MANDATORY SERVICE BULLETIN

MSB 42-138

MSB 42NG-080

Replacement of Fuel Tank Connection Hoses.

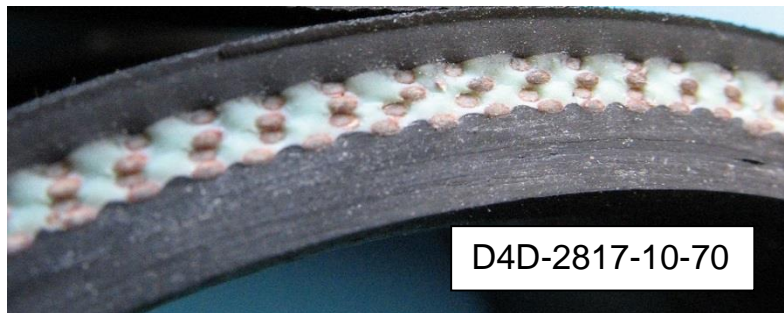
Note: The following pictures show the difference between the two types of fuel tank connection hoses in field.

- D4D-2817-10-70
 This fuel tank connection hose has a light blue layer in the cross-section. Only a fraction of these hoses come from the affected two batches.

- D4D-2817-10-70_01
 This fuel tank connection hose has an all black cross section and is not affected.

Quantity	Part Number	Description
4	D4D-2817-10-70_01	fuel tank connection hose
